**PUD &
SUBDIVISION STAFF REPORT****Date: June 5, 2003**

DEVELOPMENT NAME Long Street Bungalows

SUBDIVISION NAME Long Street Bungalows Subdivision

CONTEMPLATED USE Single-Family Residential Subdivision with reduced lot widths, reduced building setbacks, and shared parking.

SITE PLAN

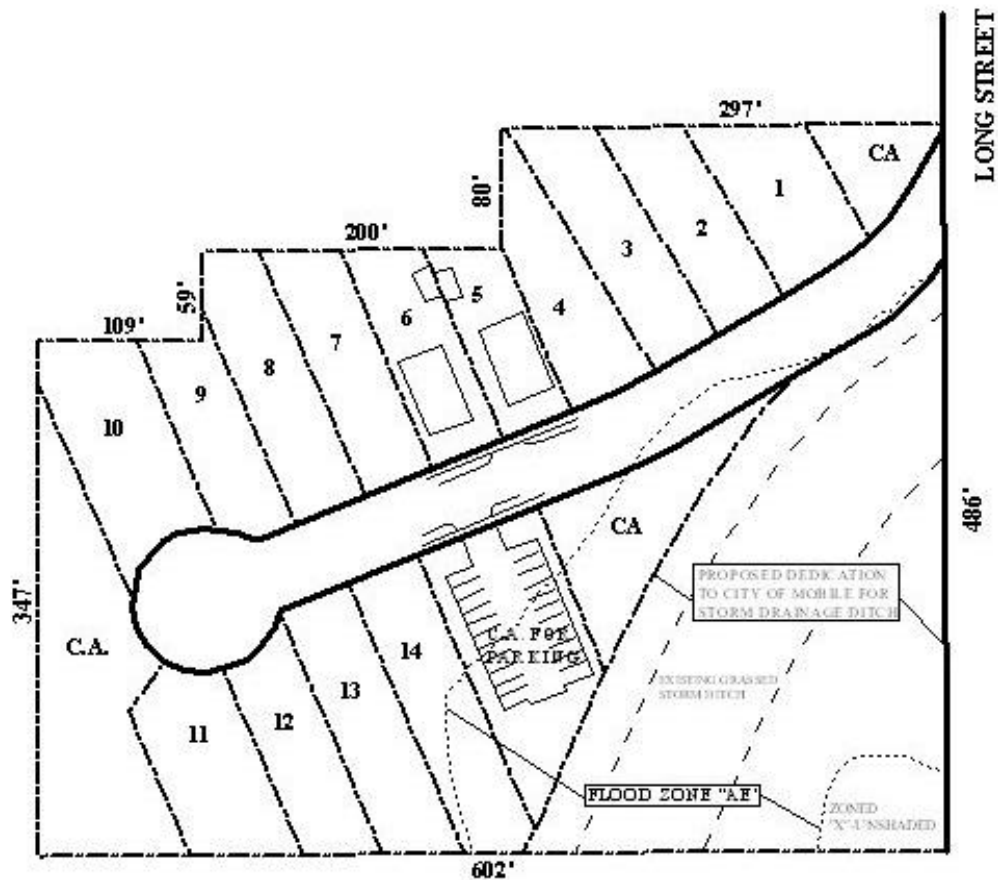
The plans indicate the dedication of the existing storm ditch, as well as additional property on each side, which appears sufficient to provide the easement requested by the Engineering Department.

Also shown on the plan are four common areas – one for storm water detention, two for resident use and the fourth a parking court for guest and overflow parking. To maintain the residential character of the development, it would be appropriate for this facility to be of an approved alternative parking surface.

Subdivision: based on the preceding, the plat is recommended for Tentative Approval subject to the following conditions: 1) exact road location and design to be coordinated with Urban Forestry, Planning and Engineering prior to issuance of any permits; 2) building setbacks to be coordinated with Urban Forestry and Planning, and reflected on the final plat; 3) construction of Long Street, from Old Shell Road to the proposed street, to a standard approved by City Engineering; 4) dedication and construction of the proposed street to city standards; 5) provision of sidewalks for the entire development, including the West side of Long Street; 6) dedication of the drainage right-of-way as shown on the plan submitted; and 7) placement of a note on the final plat stating that all common areas to be maintained by the property owners.
